Subject: 10CFR21 Reporting of Defects and Non-Compliance -  
Engine Systems, Inc. Report No. 10CFR21-0102, Rev. 0

Air Start Motors with Friction-Clutch Inertia Drives

**Report No. 10CFR21-0102**

COMPONENT: Air Start Motors with friction-clutch inertia drives

**EXPLODED VIEW OF FRICTION-CLUTCH INERTIA DRIVE**

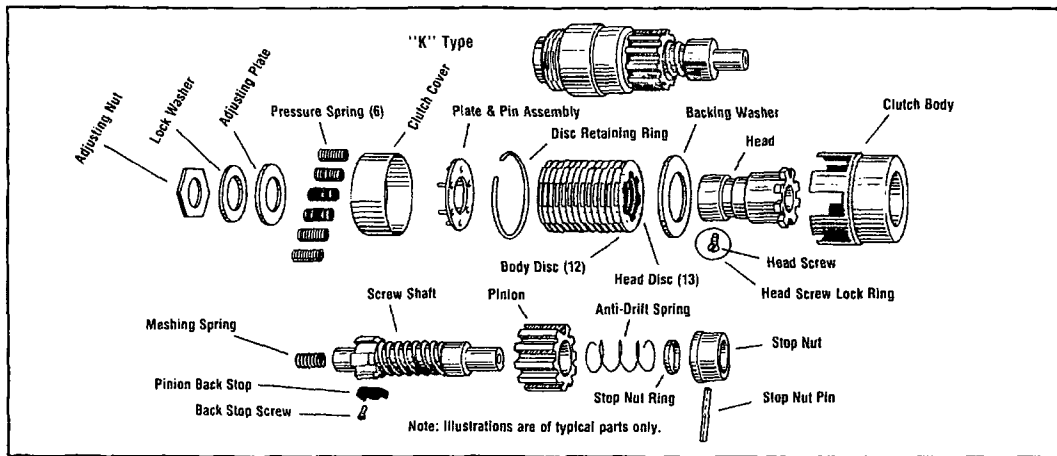
The evaluation was concluded on 08/01/11 and determined the air motor failure to be a reportable defect as defined by 10CFR21. The starter drive failure was attributed to excessive torque adjustment of the clutch assembly. This overstressed the clutch disc plates which lead to eventual failure of the friction-clutch inertia drive assembly. Failure of the clutch drive renders the air start motor inoperative. Depending upon the configuration of the engine’s starting system, an inoperative air start motor could cause excessive starting times or a start failure. Either scenario has the potential to prevent the emergency diesel generator from performing its safety related function.

Clutch torque testing was performed on the six (6) starters returned from Clinton's inventory. Results are listed below and indicate inconsistent clutch settings. The specified torque setting for the clutch drive is 275-300 ft-lbs. Of the six starters tested, only one was within specification.

Users should return any of the suspect air start motors in their inventory to ESI for verification of the inertia drive clutch torque setting. These starters can then be used to replace currently installed starters once the torque setting is verified.

At the next available maintenance interval, users should return any installed starters to ESI for verification of the inertia drive clutch torque setting.

ESI will include clutch torque setting verification in the dedication process for all future shipments of air start motors with friction-clutch inertia drives.
